SUBJECT: Calvert Cliffs Nuclear Power Plant
Unit No. 2; Docket No. 50-318
Technical Specification Change - Low Temperature Overpressure
Protection (TAC No. 76130)

LTOP SYSTEM DESCRIPTION CALVERT CLIFFS NUCLEAR POWER PLANT UNIT 2

Figure 1
Calvert Cliffs PORV Performance
Liquid Discharge Equilibrium Pressure

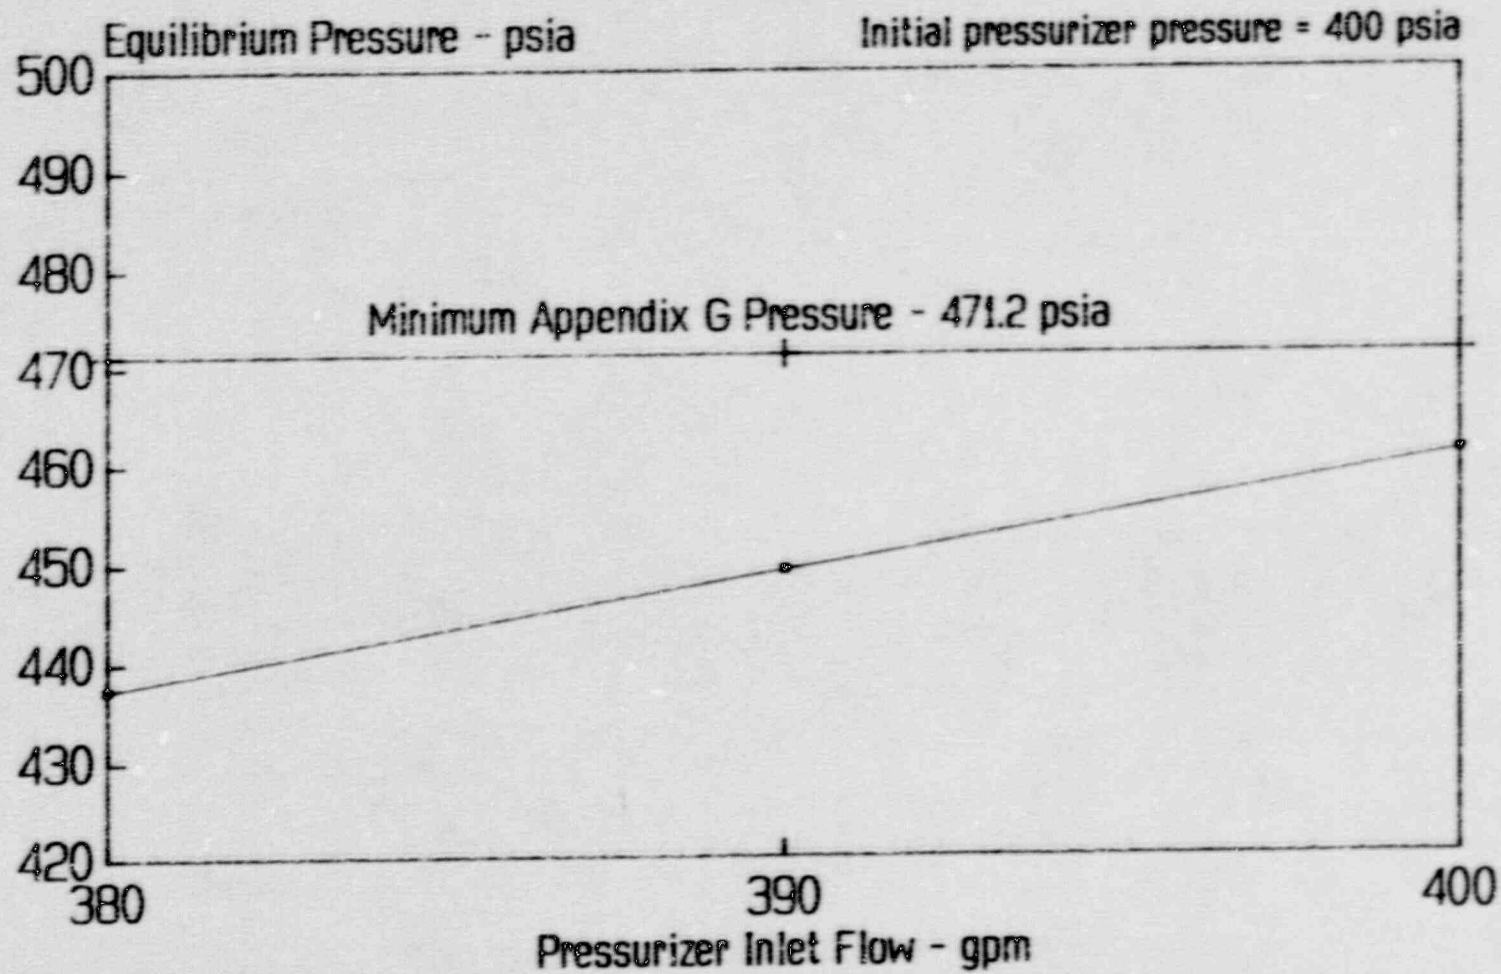
4.2.2 Figure 1 is used to demonstrate that a maximum allowed liquid flow of 380 gpm through the PORV will result in a pressurizer pressure below the minimum Appendix G limit of 471.2 psia. A total flow limit of 380 gpm will protect the minimum Appendix G limit for a range of initial RCS temperatures from 70°F to 305°F, and pressures from 50 psia to 400 psia. HPSI flow is limited to 210 gpm to allow for
